Technical Service Bulletin: TSB210009

New Cylinder Block to Reduce MCRS Fuel Pump Malfunction

Figure 1, Location of New Drilling in Left Bank of New Cylinder Block Part Number.

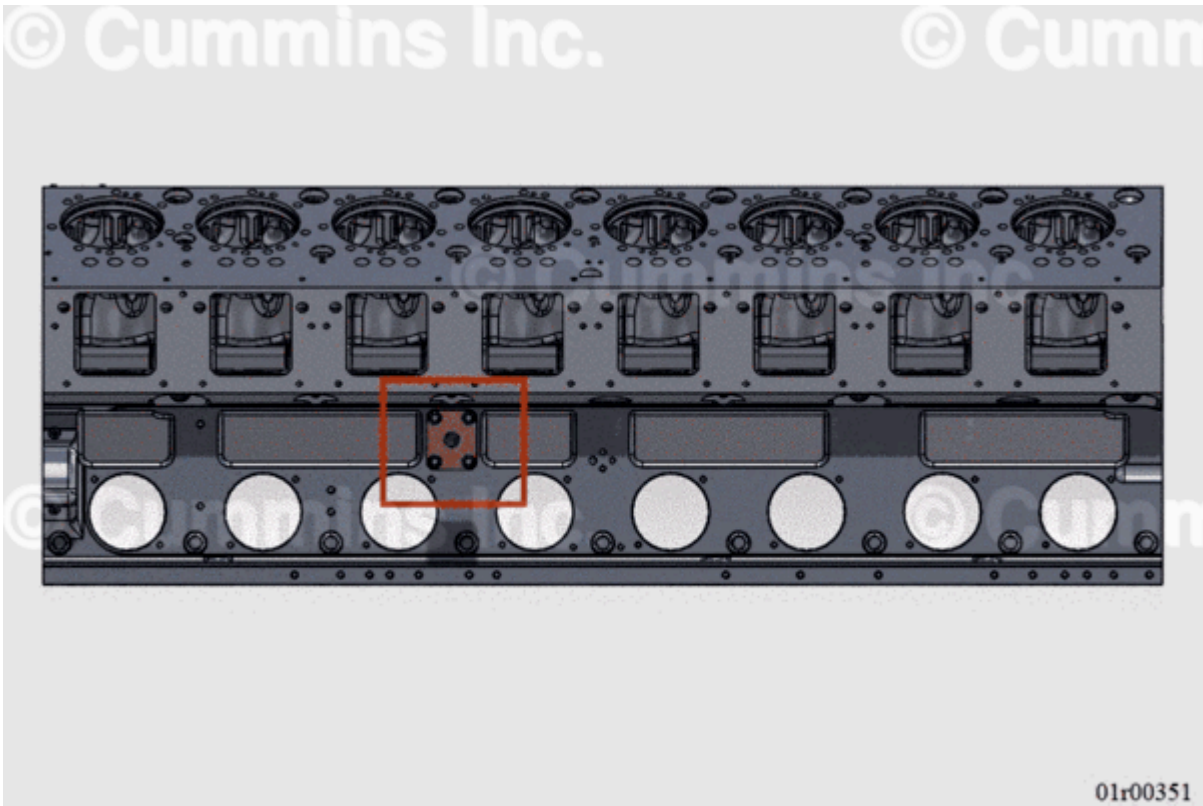
- To increase the oil supply pressure to the MCRS fuel pump, a new cylinder block has been released with a new drilling on the left bank side of the cylinder block. The drilling provides a location for a dedicated high-pressure oil supply line to be linked to the MCRS fuel pump. This drilling will be utilized by Daventry production line to install this supply line once available.
- All service orders of this new cylinder block **must** block off this hole with the blanking plate provided. See Table 1 below for part numbers.

The new cylinder block part number can be identified by the hole drilled in the side of the left bank of the cylinder block. See Figure 1 below.

The new cylinder block is compatible with all older designs if the blanking plate is fitted.
